PCN# : P2A2A
Issue Date : Oct. 31, 2012

DESIGN/PROCESS CHANGE NOTIFICATION

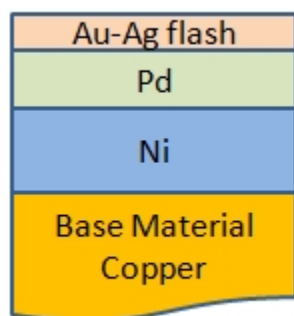
1) Standard leadframe with NiPdAu plating finish.

2) No tie bar connected to the corner leads of the package. Package outline view and diagram as shown in the table below.

1) Roughened leadframe with NiPdAuAg plating finish.

2) Added tie bar to the corner leads of the package. Package outline view and diagram as shown in the table below.
